Wetland Impacts West Essex Highlands

June 4, 2025

Mark Gallagher

DA-2

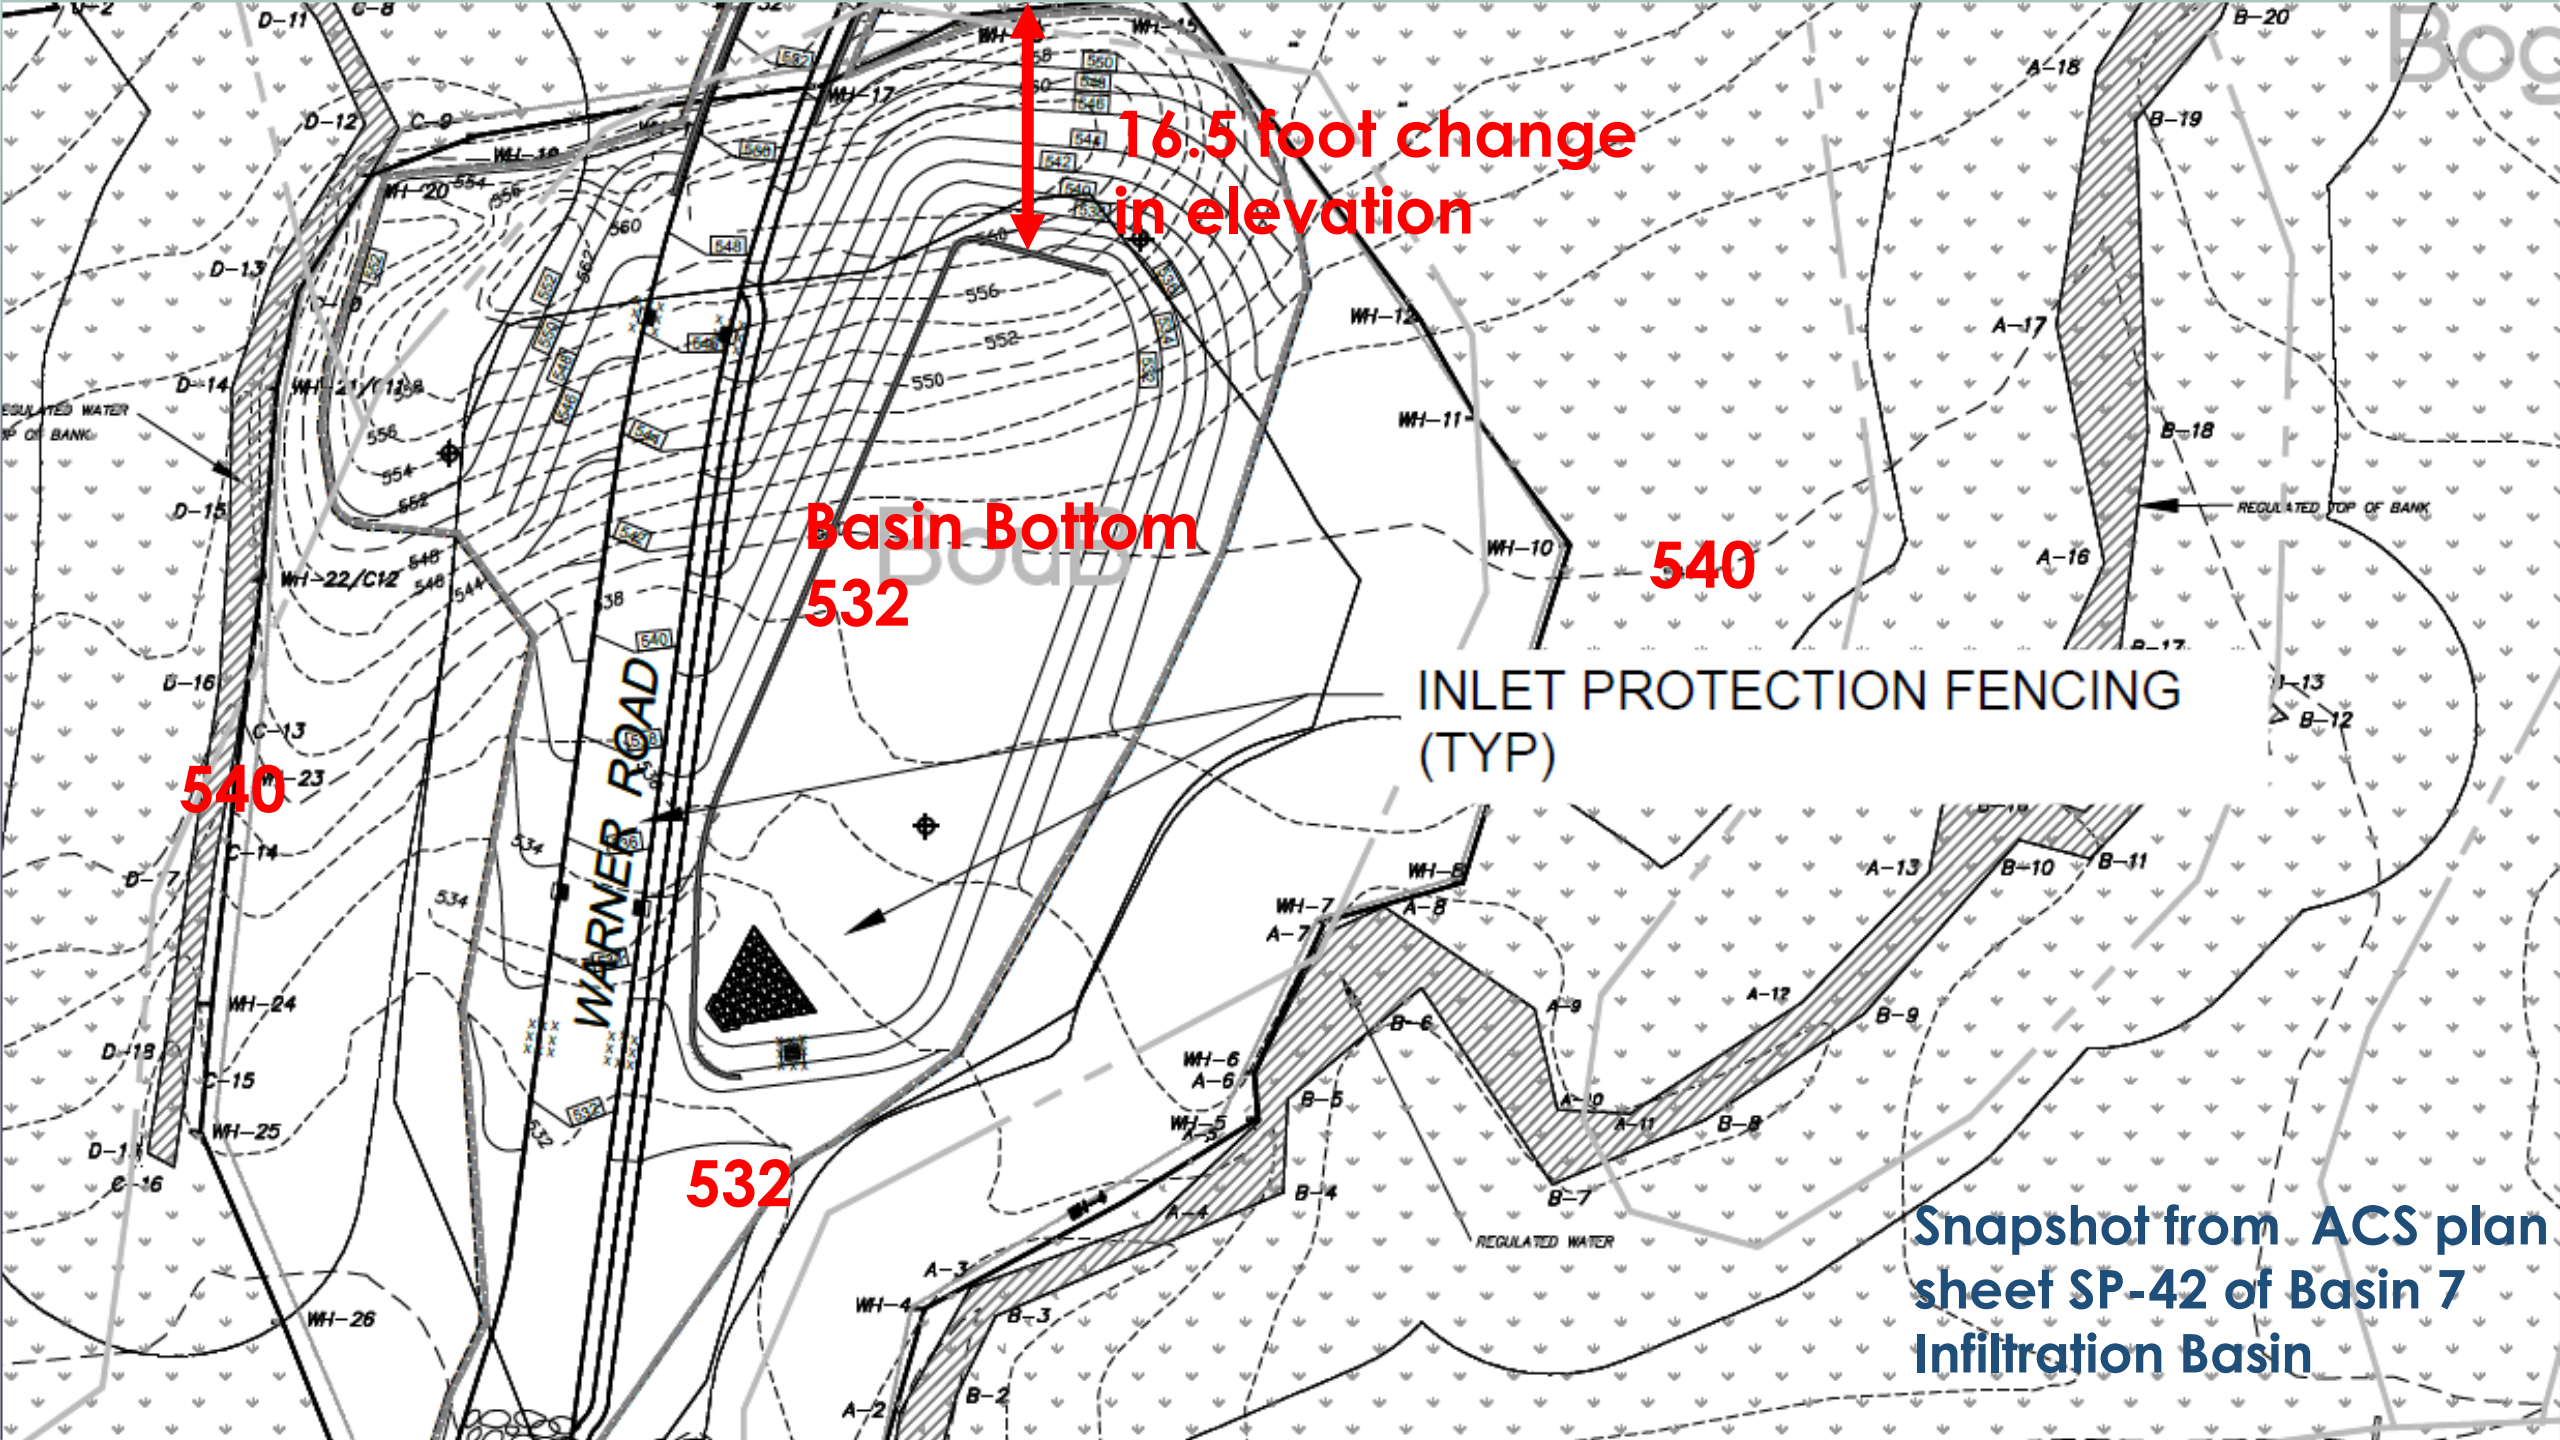
Western wetlands drain 32 acres. It will be reduced by 9 acres, or 28% of the total existing drainage area.

Eastern wetlands drain 48.4 acres. It will be reduced by 16 acres, or 33% of the total existing drainage area.

Snapshot from
ACS plan sheet
SP-42 of Basin 7

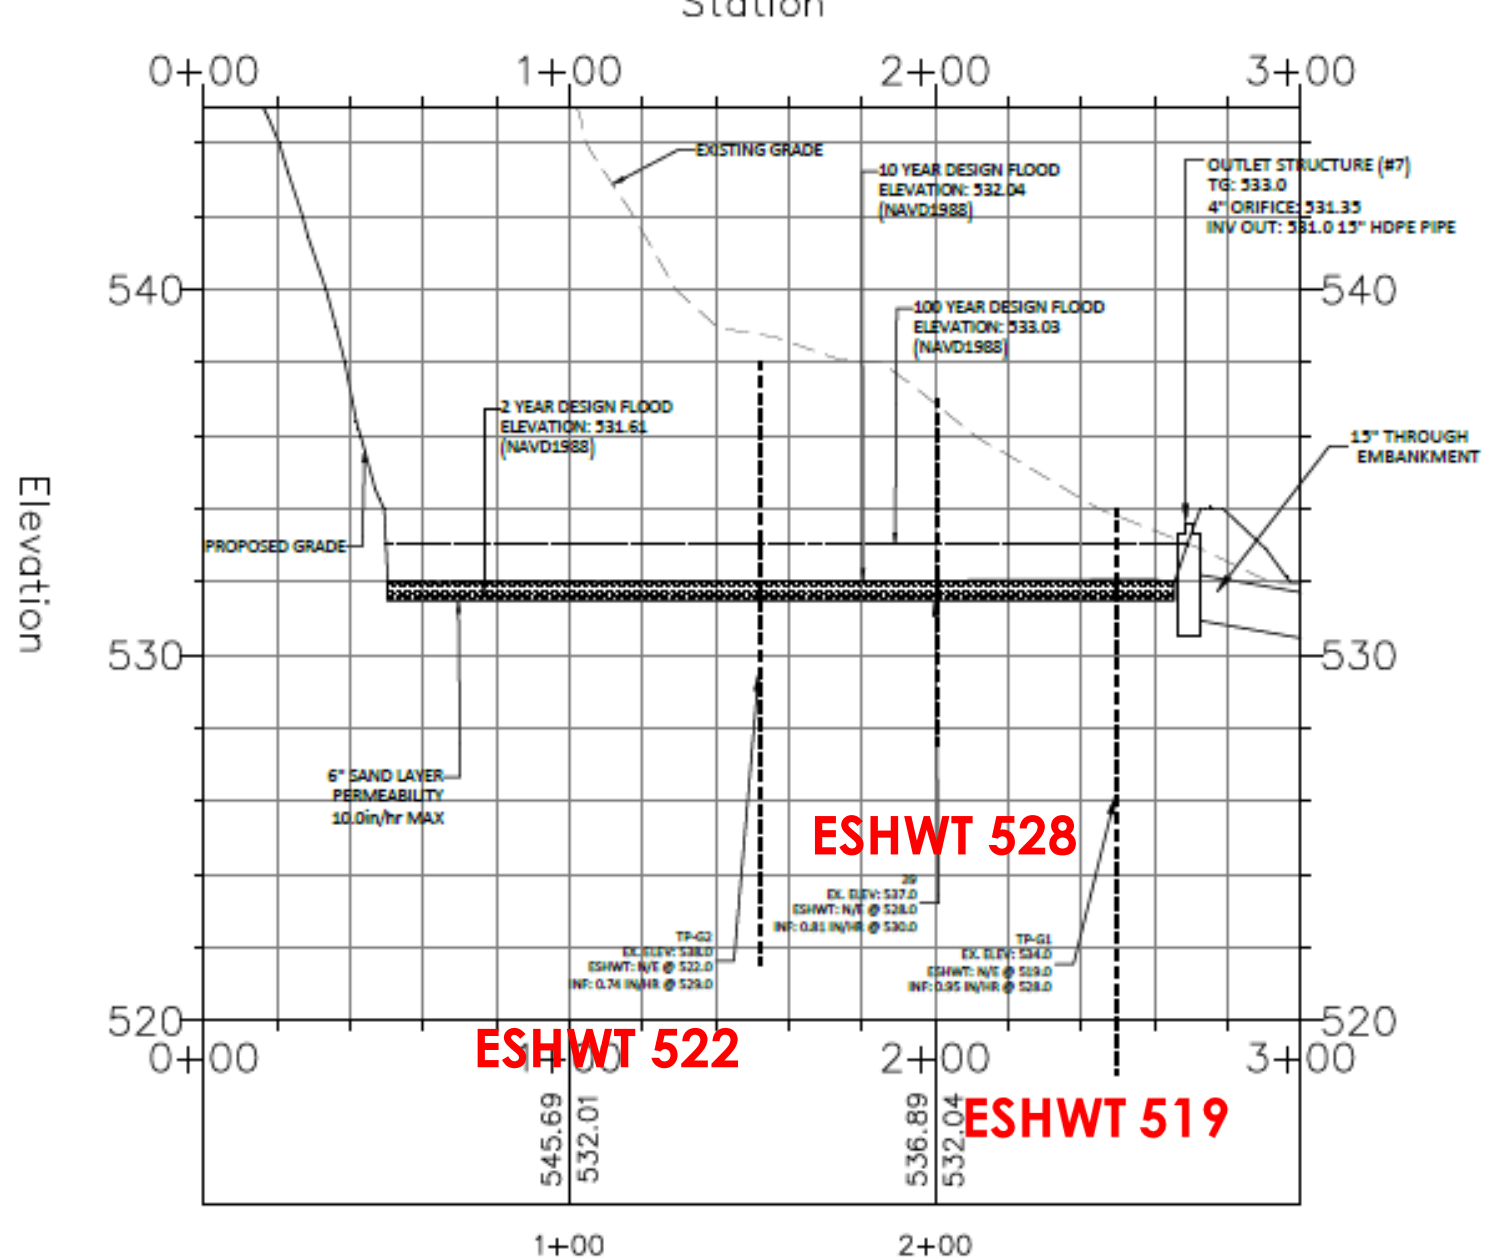
Groundwater elevations and flow paths tend to follow restrictive layers such as fragipans or bedrock. Based on the USDA Soil Survey the three main soils types on site, Boonton, Haledon and Hasbrouck all have a fragipan that perches water.

This is especially important early in the growing season.

16.5 foot change
in elevation

Snapshot from ACS plan
sheet SP-42 of Basin 7
Infiltration Basin

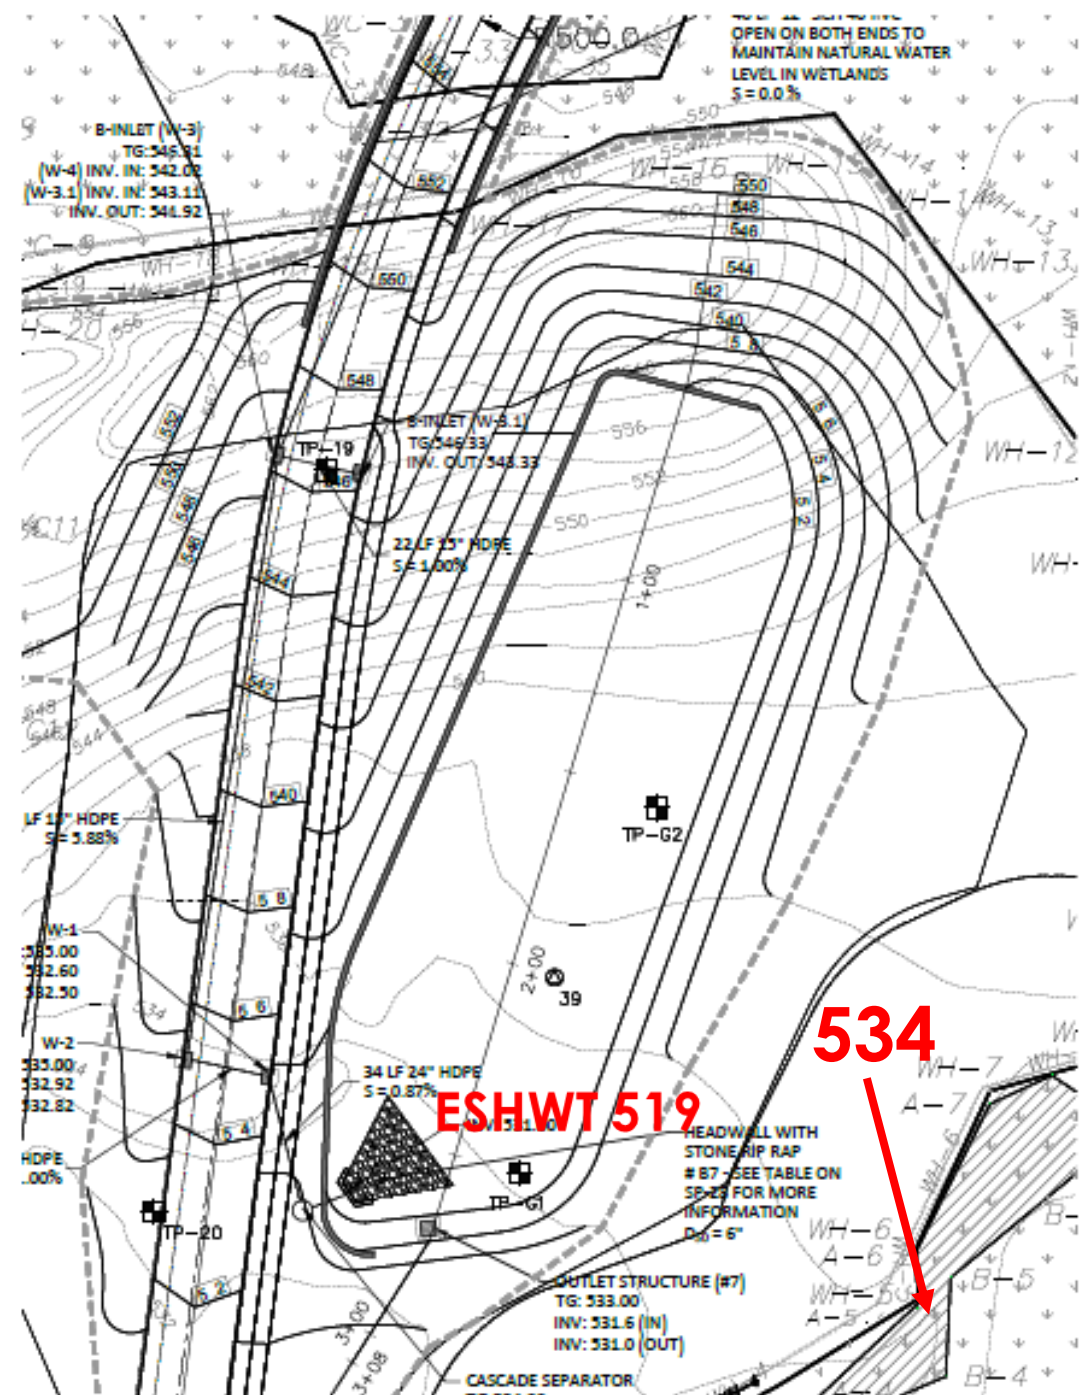
ESHWT 15 feet lower than
the adjacent wetland?
